STAFF REPORT

SITE PLAN COMMITTEE

Address: 11 Bronte Road,
2405, 2409 and 2411 Ontario Street, and
56 Jones Street

Subject: Birchgrove Estates Inc. (Cityzen Development Group)
Mixed Use Building, Townhouses and Heritage Precinct

Proposed Site Plan

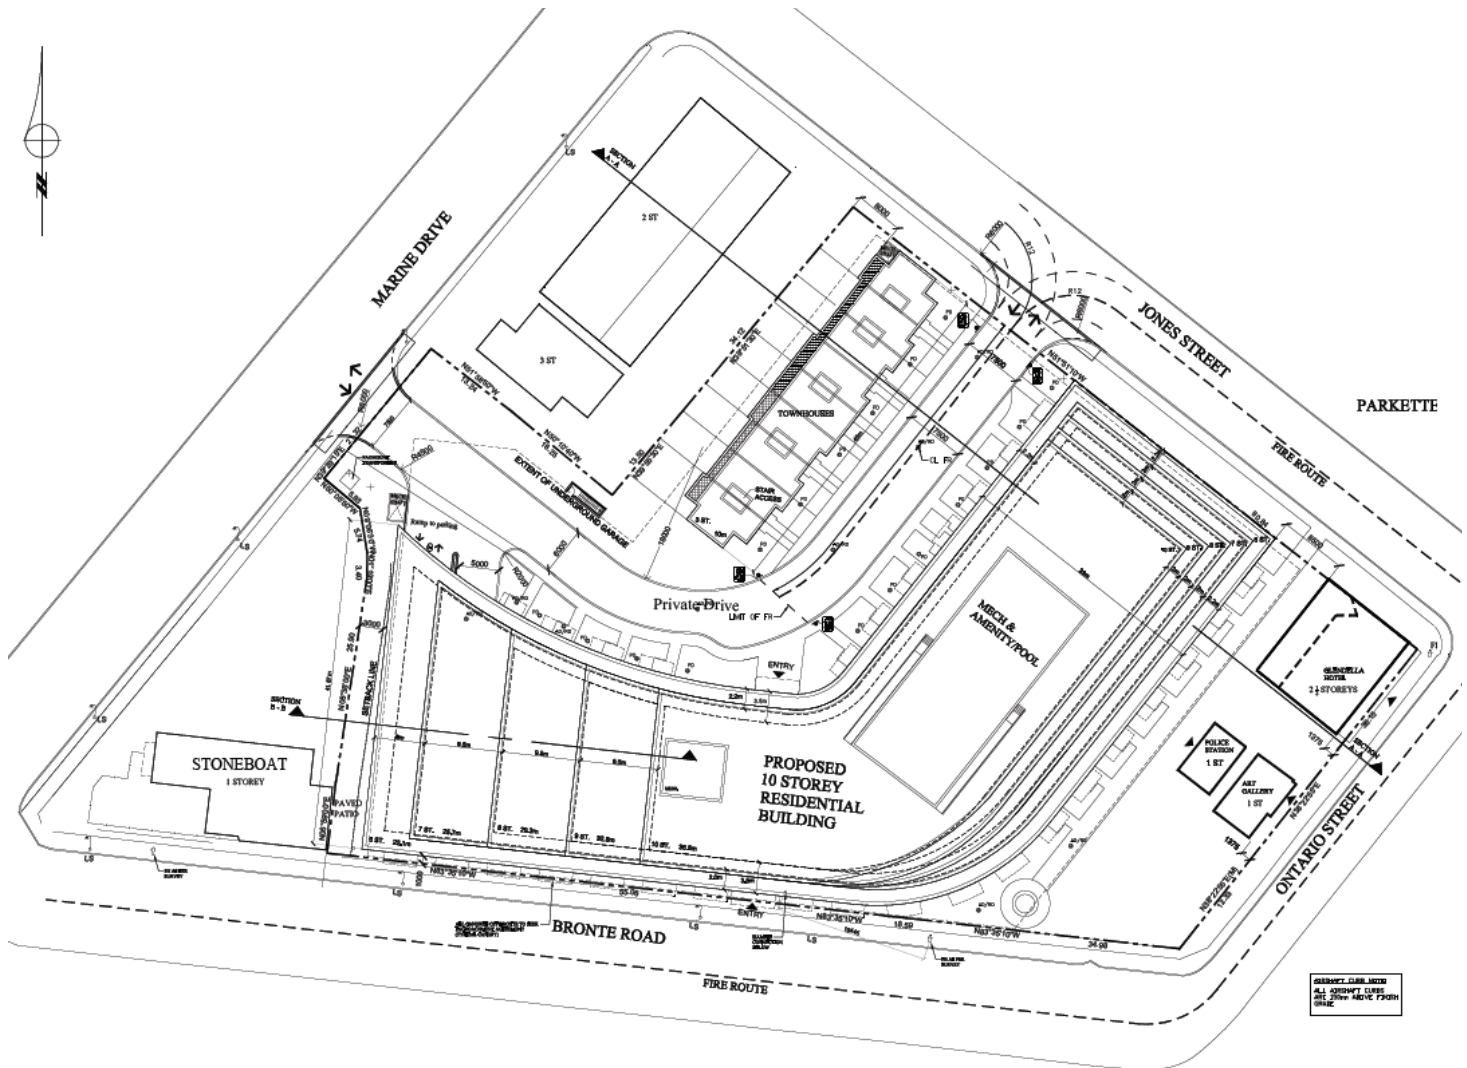
➤ ***The proposed site plan, dated September 10, 2007, is substantially in accordance with the site plan drawing dated April 24, 2007 (refer to Appendix Three).***

Site Plan (A-01) / Ground Floor Plan (A-02)

Proposed Heritage Precinct (Enlargement of Landscape Plan)

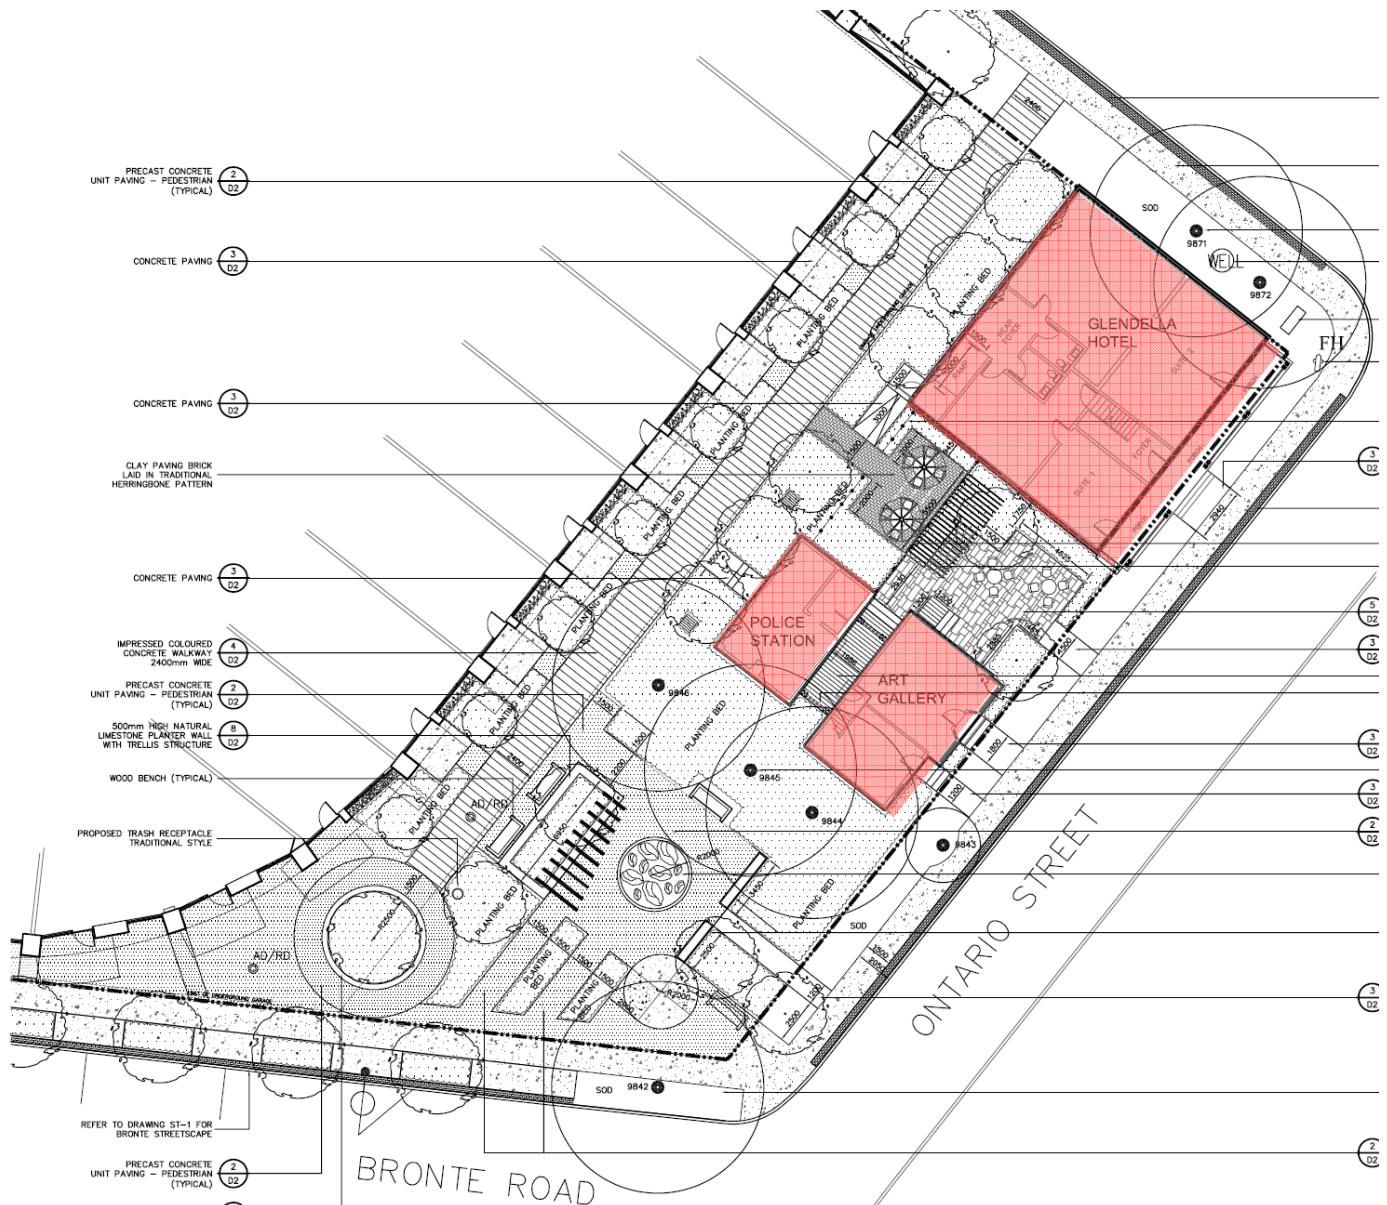
4. That Heritage Oakville has provided these comments specifically in consideration of the totality of Drawing L3 - "Heritage Walk Enlargement Plan", dated August 2007; and
5. That Heritage Oakville requests that the Site Plan Committee seek the input of the Chair and Vice Chair of Heritage Oakville on the landscaping and paving materials.

Within the heritage precinct, the mews provides pedestrian access across the southern portion of the site and provides connections to the open spaces, gardens, heritage buildings, at-grade commercial and live/work uses. Landscaping within this area incorporates existing mature trees, which are complemented with a new line of trees to accentuate the axial character along the north perimeter of the precinct, extensive ground plantings, patio spaces, trellis structures and traditional-style lighting standards.

- East corner of rock plaza appears to be very close to an existing tree. Revise plaza layout to accommodate root zone of tree.
- Provide additional space around feature tree at the mews terminus, to accommodate people sitting on the circular seatwall and pedestrians. 1.5m wide walk provided, minimum 2m width is recommended.

- Provide additional rooting space for the feature tree at the mews terminus. There is approximately 4.5m³ of soil volume proposed, however, based on City of Toronto standards a tree with future canopy of approximately 12m requires 36m³ of rooting space. With only minor modification to the plan an approximate 6m diameter planter could be accommodated and will provide approximately 22m³ rooting space sufficient for a mid size tree. Ideally a 7m diameter planter would approximately provide the 36m³ required. The applicant is encouraged to propose a layout that would achieve this, so a tree species with potential for a large canopy can be installed. The expanded seatwall will also strengthen the presence of the feature element, and provide additional seating in this prime location. Please note that the proposed feature tree should have a minimum 100mm caliper.

- Landscape Layout Plan indicates 100mm caliper tree to be planted in the circular planter at the terminus of the mews walk. Planting list provided specifies the Acer Rubrum 'Autumn Spire' at 70mm caliper. Correct this discrepancy.
- Provide quantities and layout for all plant material. (not just the trees)
- Show protection measures for existing vegetation to remain. Include detail as per Town standards.

Appendix Four: Drawings Proposed Bronte Streetscape Plan + Section

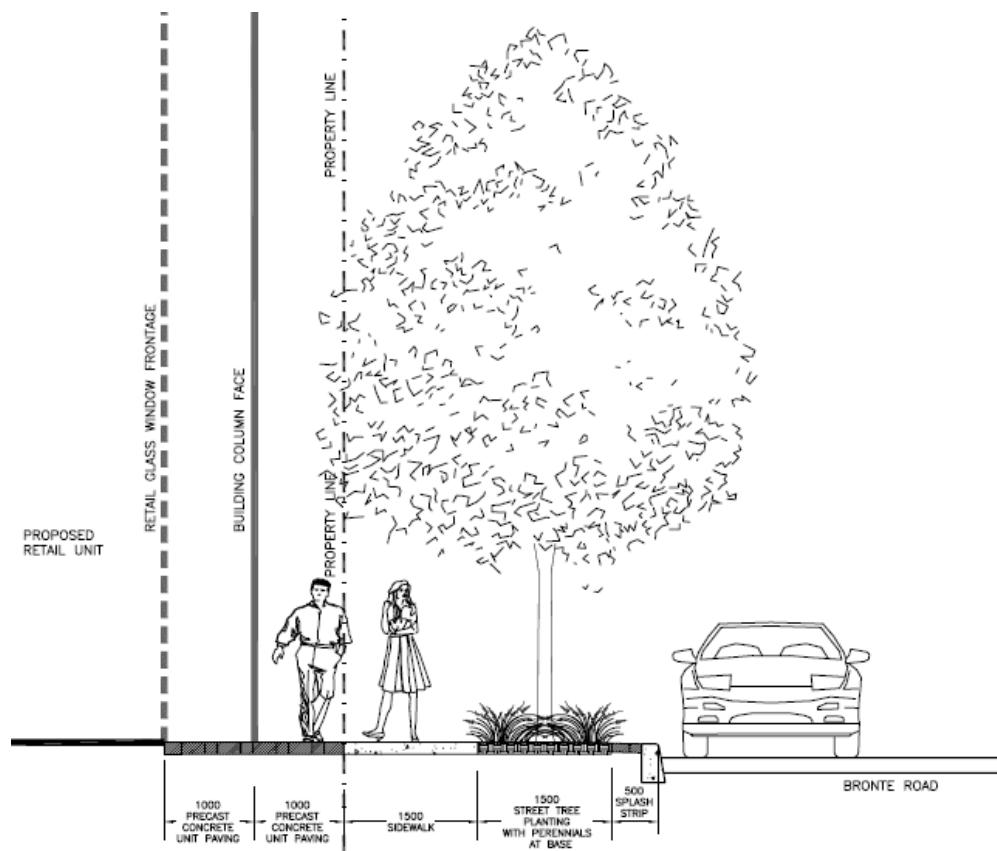
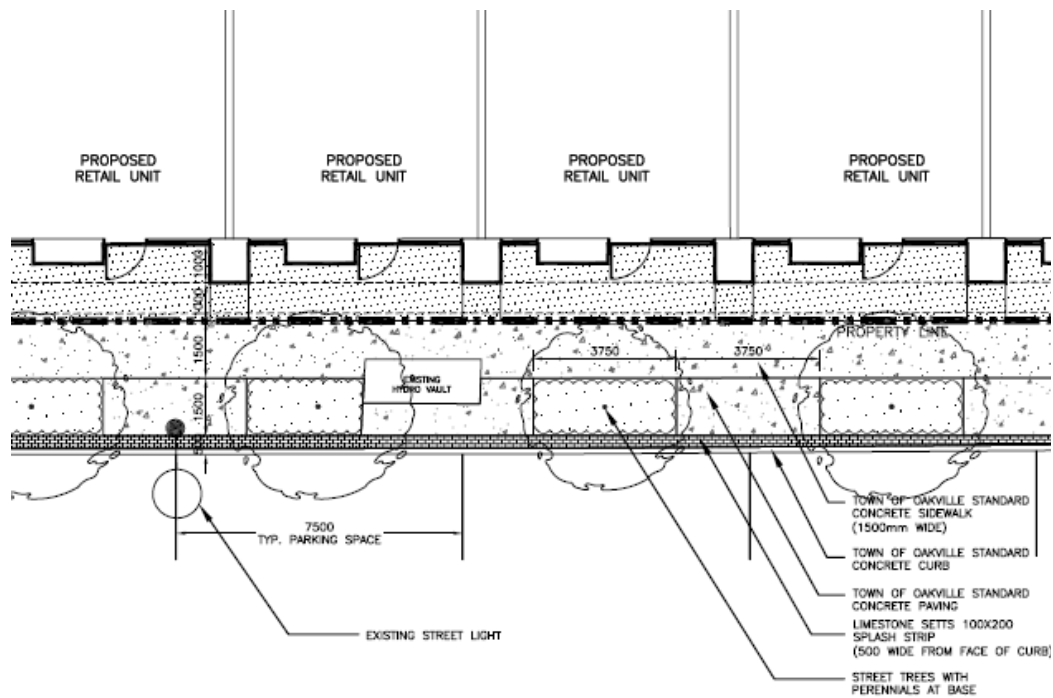
- Plan drawing indicates canopies of the retail units encroaching over p.r.o.w – consider shortening to within property boundary or discuss encroachment agreement options with Construction+ Engineering.

- Section drawing (A-A) must be revised to clearly indicate the pillars(vertical line) to represent the actual pedestrian route width (within the 'zone of the pillars' also include protruding façade elements and door swings that encroach into the usability of these niches).

- Require additional information on the proposed treatment on the boulevard side of the Ontario Street streetscape – concerned with the detail shown within the property boundary and the lack of treatment (sod) on the boulevard side. This will 'read' as two different spaces and not the seamless space anticipated. Internal meeting with concerned Depts to be undertaken to better understand what treatments can be incorporated into the p.r.o.w – this interface between public and private must be addressed, especially within the heritage precinct.
